Technical Bulletin 170

11.2016

Contents

Tightening sequence

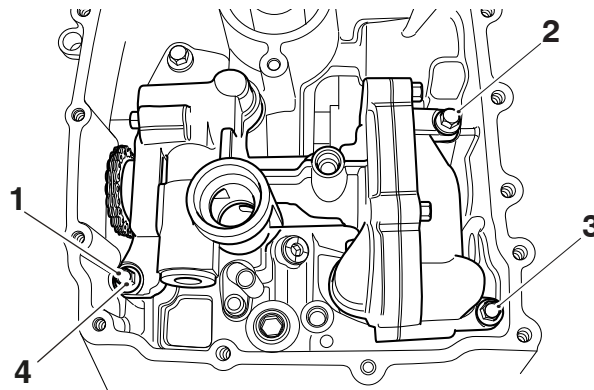
The oil and water pump tightening sequence has changed.

In addition to the instruction in the service manual, tighten the fixings in the sequence shown below to **10 Nm**.

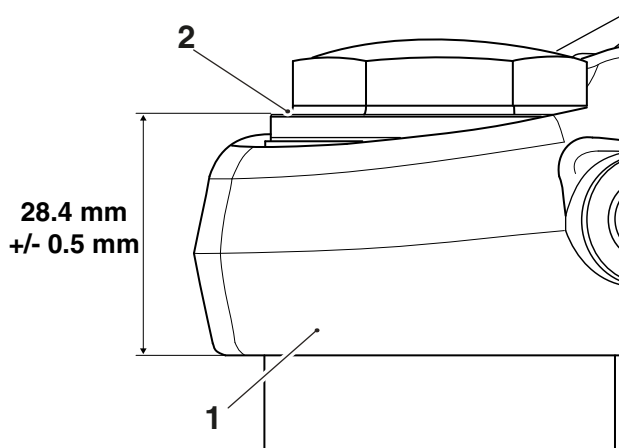
The front fork installation procedure does not reflect the information displayed in the suspension specification settings.

Therefore when measuring the fork pull through, step 3 should read:

Position the forks through the lower yoke, so that the flat portion of the top cap is 28.4 mm +/- 0.5 mm from the lower edge of the upper yoke.

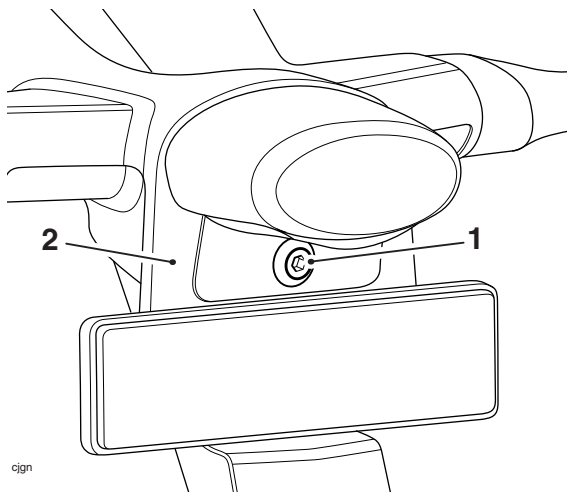
The lock nut fastening the licence plate light holder has been replaced with a captive nut on motorcycles from VIN 771857, therefore there is no longer a requirement to disassemble the licence plate assembly when replacing the licence plate bulb.

The torque figure remains unchanged at **2 Nm**.

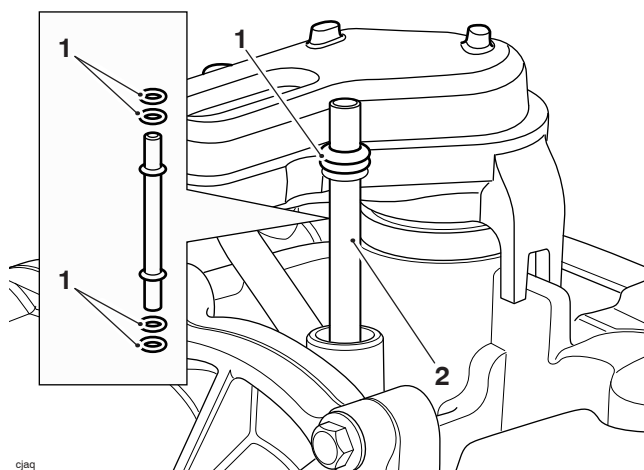
A soft petroleum jelly, is now used to lubricate the O-rings during installation of the coolant drain tube during manufacture. Triumph therefore recommend that if the sump or coolant drain tube are removed for any reason the O-rings must be replaced and coated with a commercially available soft petroleum jelly to aid installation.

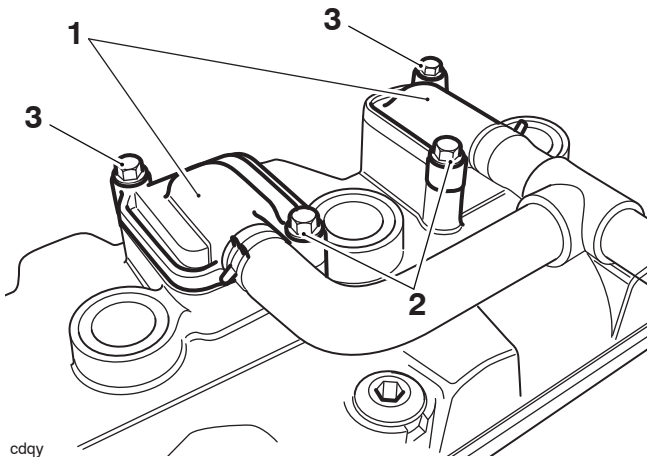
The two front fixings for the secondary air injection valve covers have increased to 25 mm from engine number 791976 (all markets except Brazil) or 792241 (Brazil only) and are not retrofittable. The rear fixings remain unchanged at 20 mm.

Therefore if the camshaft cover is replaced on models up to engine number 791975 (ROW) or 792240 (Brazil only), discard the two front 20 mm fixings and replace with new 25 mm fixings.

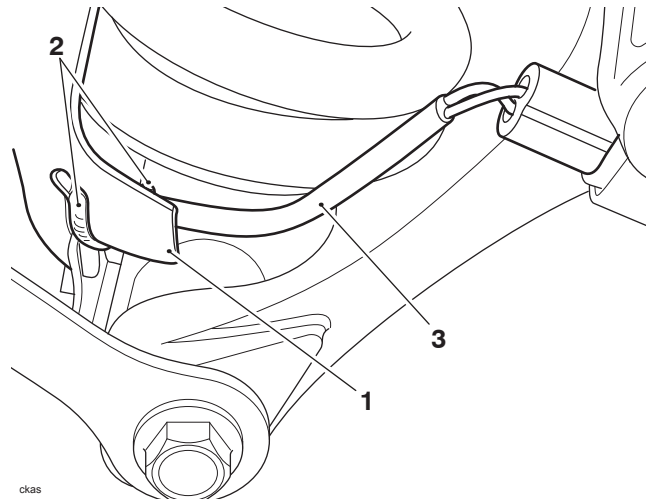
The Rear Suspension Unit (RSU) flylead is secured to the splashguard with a cable tie, part number T3700015 from VIN number 777835 (ROW) or 778620 (Brazil only).

Therefore when refitting the flylead or RSU, secure the flylead with a cable tie as shown in the illustration.

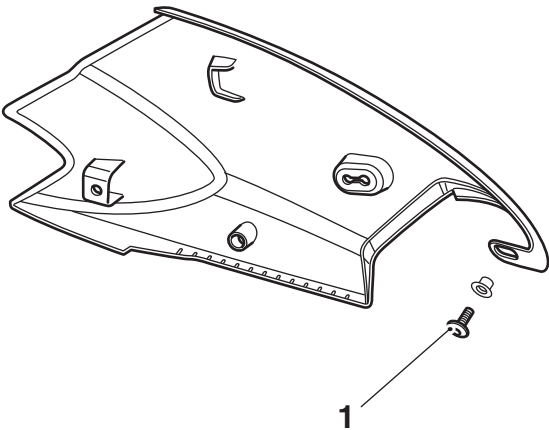
The torque figure has changed. If loosened or removed for any reason the fixing(s) must be torqued as required.

Application	Torque (Nm)	Notes
Side bodywork fixings	5 Nm

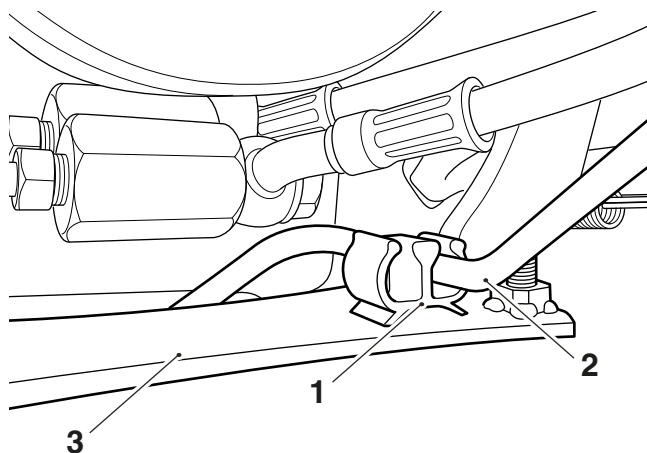
Euro 4 model motorcycles from VIN 780498 have an additional clip added to the header pipe strap to support the brake line. The removal and installation procedures remain the same with the addition of removing and refitting of the brake line from and to the clip during removal and installation.
